# SUBDIVISION REPORT - CONCEPT/DEVELOPMENT PLAN

► FILE #:	1-SF-23-C	AGENDA ITEM #:	40
	1-E-23-DP	AGENDA DATE:	7/13/2023
POSTPONEMENT(S):	1/12/2023, 2/9/2023		
► SUBDIVISION:	BEELER ROAD SUBDIVISION		
► APPLICANT/DEVELOPER:	MESANA INVESTMENTS - BEELER ROAD		
OWNER(S):	Mesana Investments, LLC		
<hr/>			
TAX IDENTIFICATION:	29 188.03	<a href="#">View map on KGIS</a>	
JURISDICTION:	County Commission District 8		
STREET ADDRESS:	0 BEELER RD		
► LOCATION:	East and west side of Beeler Rd, south of Beeler Farms Ln		
SECTOR PLAN:	Northeast County		
GROWTH POLICY PLAN:	Planned Growth Area		
WATERSHED:	Beaver Creek		
► APPROXIMATE ACREAGE:	27.65 acres		
<hr/>			
► ZONING:	PR (Planned Residential)		
► EXISTING LAND USE:	Agriculture/Forestry/Vacant Land		
► PROPOSED USE:	Detached residential subdivision		
SURROUNDING LAND USE AND ZONING:	North: Single family residential -- PR (Planned Residential) up to 3.25 du/ac South: Single family residential, rural residential, agriculture/forestry/vacant -- A (Agricultural) East: Agriculture/forestry/vacant -- PR (Planned Residential) up to 2 du/ac West: Agriculture/forestry/vacant, rural residential, single family residential -- PR (Planned Residential)

## *Requested Variances & Alternative Design Standards*

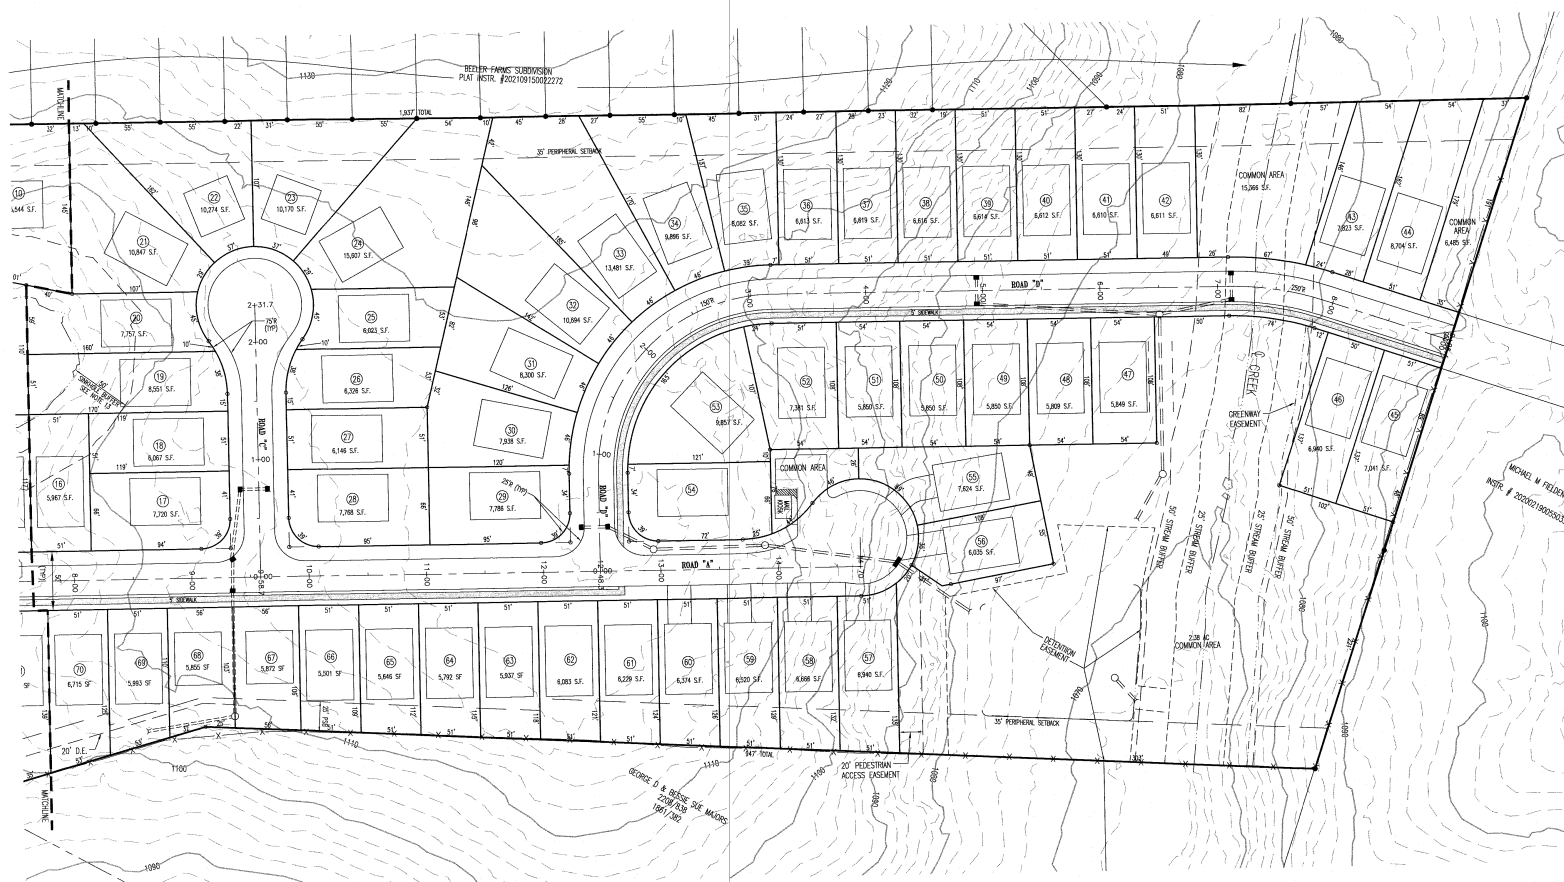
1. Reduce the minimum vertical curve on Road 'A' from K=25 to K=15 at STA 0+75

1. Reduce the minimum horizontal curve radius from 250' to 150' at STA 2+25 on Road 'D'

1. Increase the maximum intersection grade from 1% to 3% on Road 'A' at Beeler Road
2. Increase the maximum intersection grade from 1% to 3% on Road 'B' at Road 'A'
3. Increase the maximum intersection grade from 1% to 2% on Road 'C' at Road 'A'
4. Increase the maximum intersection grade from 1% to 2.09% on Road 'D' at Road 'A'

Approve since the requested variances will not create unsafe conditions.

**\*\*The maximum intersection grade is 2% where there is a pedestrian crosswalk\*\***

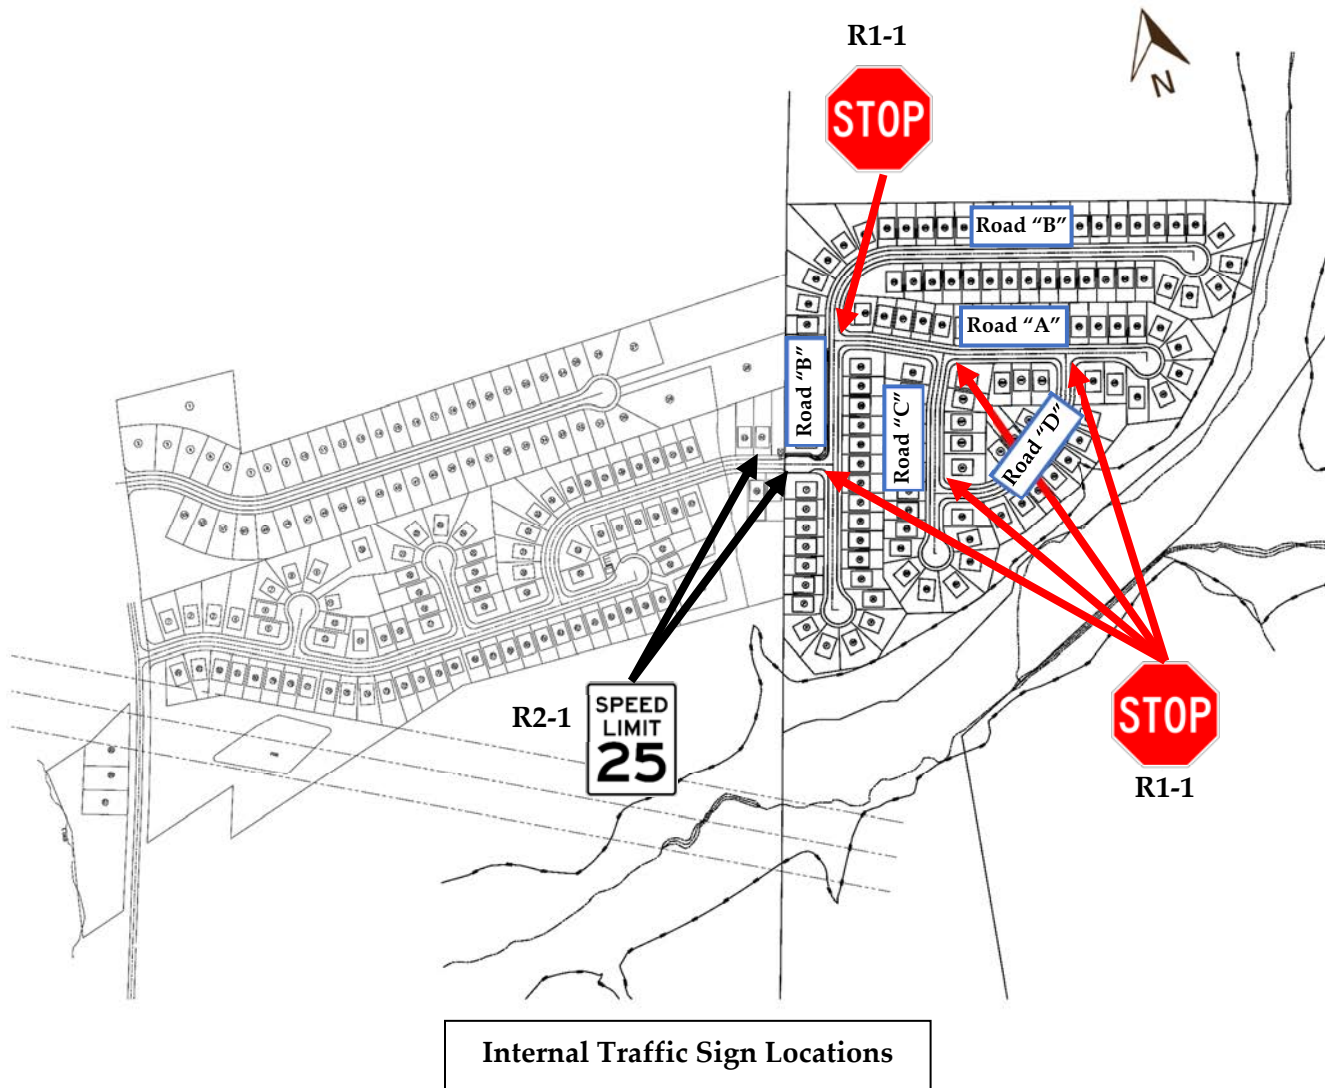
**Fairview Road Subdivision Internal Roads:** The layout plan shows one entrance via Beeler Road Subdivision, as shown in Figure 3 and below.

- 4a) Two 25-mph Speed Limit (R2-1) signs are recommended to be installed on the connector road between Beeler Road and Fairview Road Subdivisions. One sign should be installed for eastbound travel into Fairview Road Subdivision and one for westbound travel into the Beeler Road Subdivision. This recommendation will provide a reinforcement notification of the speed limit within the subdivisions.
- 4b) Stop Signs (R1-1) with 24" white stop bars and other traffic signage are recommended to be installed at the internal locations in Fairview Road Subdivision, as shown below:
